HISTORIC AND DESIGN REVIEW COMMISSION

November 1, 2017

HDRC CASE NO: 2017-530
ADDRESS: 925 BURNET ST
LEGAL DESCRIPTION: NCB 01656 BLK D LOT W 25 FT OF N 60 FT & S 131 FT OF 16
ZONING: R-5, H
CITY COUNCIL DIST.: 2
DISTRICT: Dignowity Hill Historic District
APPLICANT: Cyrus Askin
OWNER: Cyrus Askin
TYPE OF WORK: Wood and aluminum window replacement, exterior modifications
APPLICATION RECEIVED: September 28, 2017
60-DAY REVIEW: November 27, 2017
REQUEST:

The applicant is requesting a Certificate of Appropriateness for approval to:

Window Plan (*not to scale*)

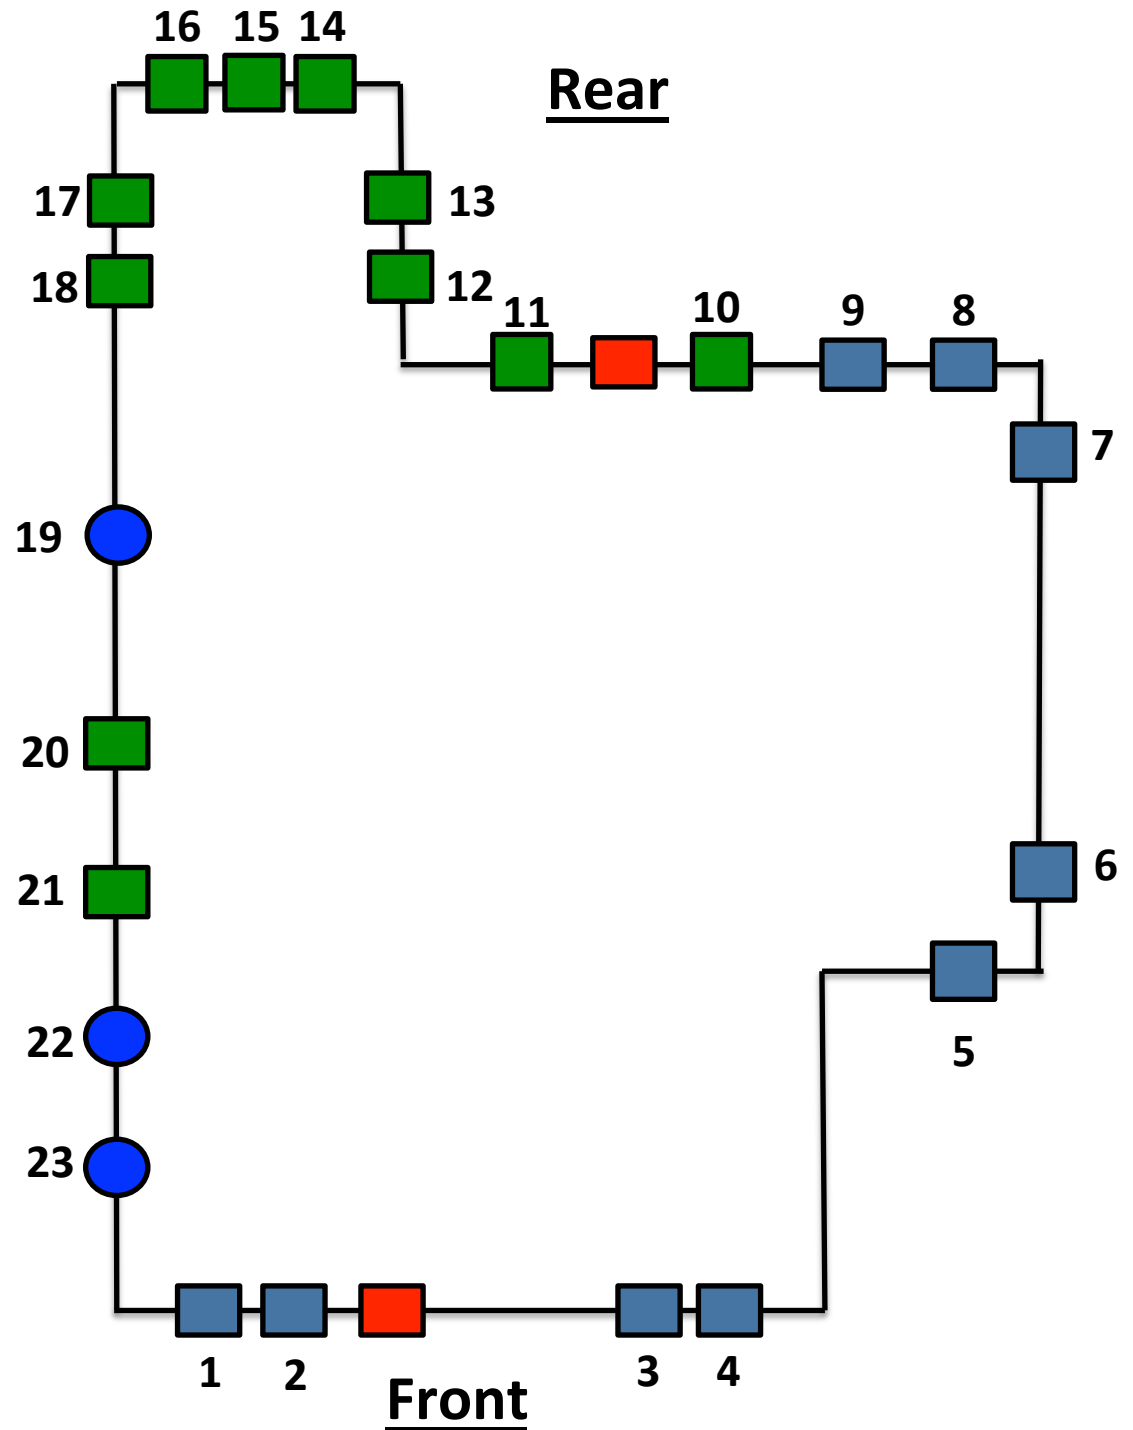
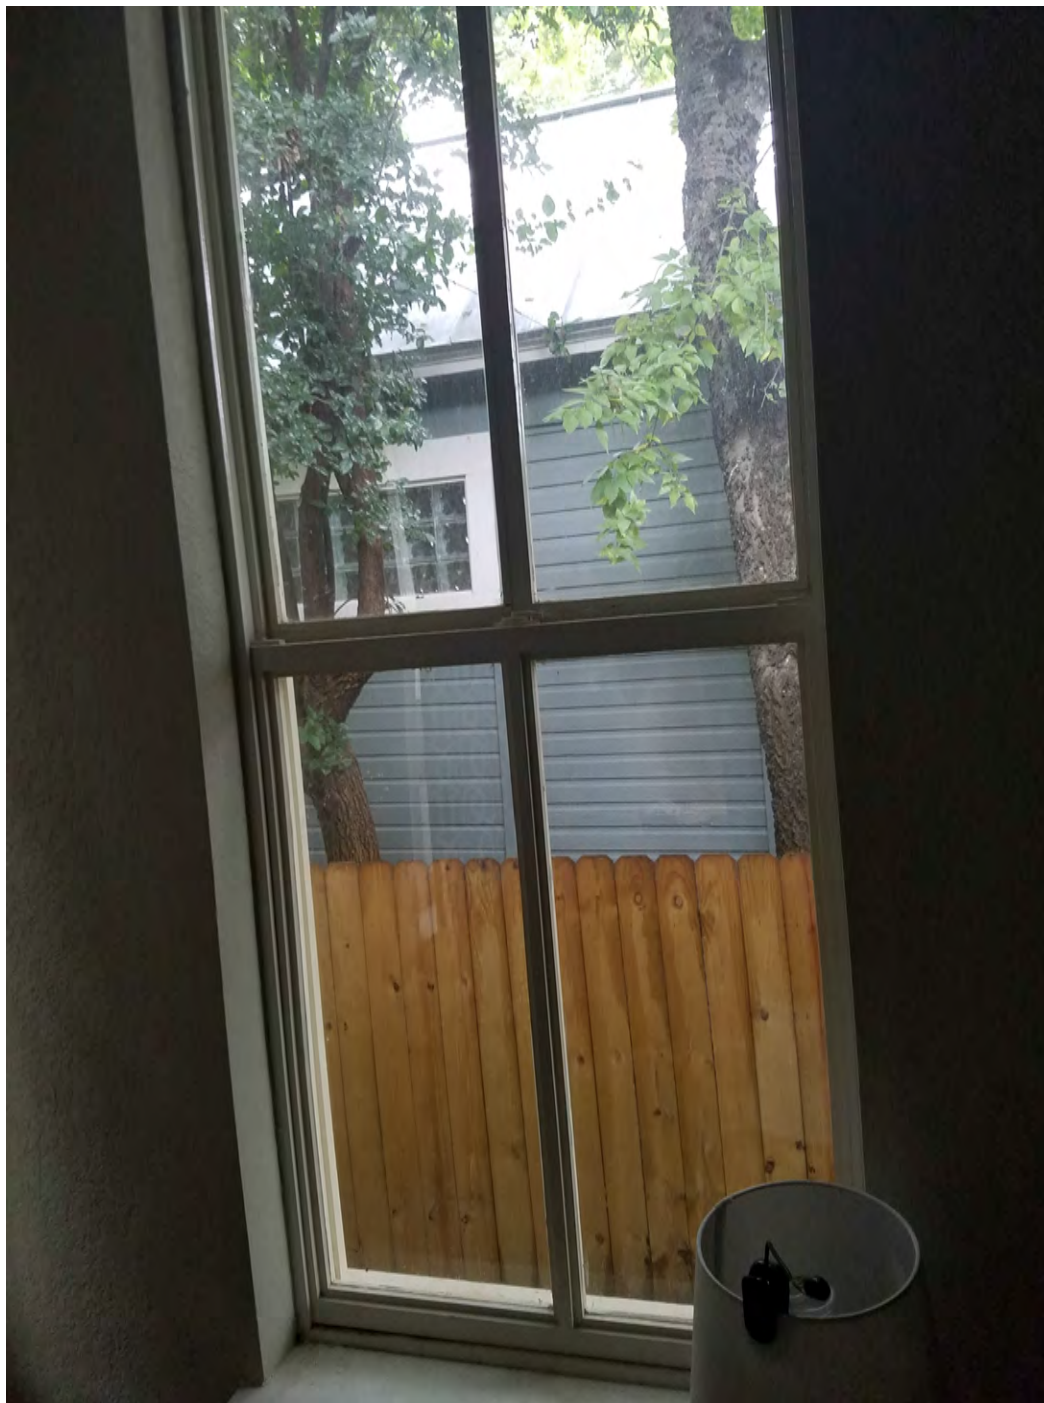
- b. The repair of the original wood windows was approved at the July 15, 2015, Historic and Design Review Commission hearing along with the replacement of aluminum windows with one over one vinyl windows. At that time, the property was under different ownership. Work was not performed consistently with the Certificate of Appropriateness. The nine historic, two over two windows were replaced with new, two over two wood windows that feature a profile that does not match that of the original windows. Two one over one wood windows were replaced with one over one vinyl windows. The existing, one over one, aluminum windows were replaced with one over one vinyl windows, consistent with the original approval. Three fixed vinyl windows were also installed at locations where previous windows were not present.

- c. Per the Guidelines for Exterior Maintenance and Alterations, 6.A.iii., historic windows should be preserved. Per 6.B.iv., new windows should be installed to match the historic or existing windows in terms of size, type, configuration, material, form, appearance and detail when original windows are deteriorated beyond repair. Per 6.B.vii., non-historic windows should be replaced with windows that are typical of the architectural style of the building.

- d. The historic structure previously featured a transom window above the door which has been removed. Staff finds that this window should be reinstalled.

Staff does not find the installed replacement windows to be a compatible replacement for the original wood windows. If the commission approves the windows as installed, then staff recommends that wood windows screens be installed as mitigation to maintain a more traditional appearance from the street.

Staff recommends approval of item #2. Staff finds that these windows have been installed in a manner that is consistent with the previous approval.

Staff recommends approval of item #3, the installation of three fixed vinyl windows where previous windows were removed.

Staff does not recommend approval of item #4, the removal of the transom window above the front door. Staff finds that this should be reinstalled.
